Aviation DOA Nr.: EASA.21J.025	<b>Retrofit-/Installation Instruction</b>	Dokumentnummer : <b>UA-AT01-7900-203</b>
	Oil pressure sensor and gauge TCDS-Nr.: EASA.A.527      Projekt-Nr.: 00441	Ausgabe: A.01 Seite: 1 von 8

This Installation Instruction has been translated from the German Original UA-AT01-7900-003  
 The translation has been performed to the best of our knowledge and judgement.

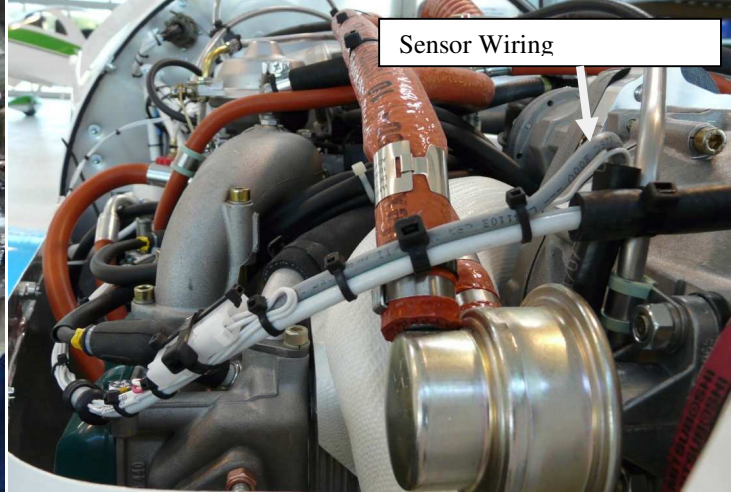
This retrofit instruction provides all necessary information for the change of the oil pressure gauge system. The previous ROTAX oil pressure sensor is no longer available. The change of the oil pressure sensor caused a change of the oil pressure gauge, because the new sensor uses a different operating principle. Furthermore, an additional wire has to be moved from the sensor to the instrument panel.
